Objecting Submission to State Significant Development

Project Number SSD-10315, Bowmans Creek Wind Farm

10 May 2021

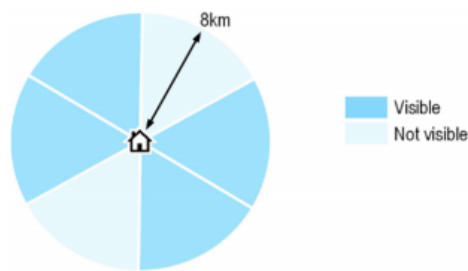
2. Considering the images 'Plate 3' (page 29), image 'Plate 4' (page 30) and image 'Plate 8' (page 32) of the 02 APP H Visual Assessment report, it is clear that there will be a significant impact on the surrounding land, specifically in relation to land clearing, loss of livestock feed and space, noise, increased road traffic, dust and increased air pollution. It will not be possible to implement substation facilities as shown in the abovenamed images without unacceptable impacts.
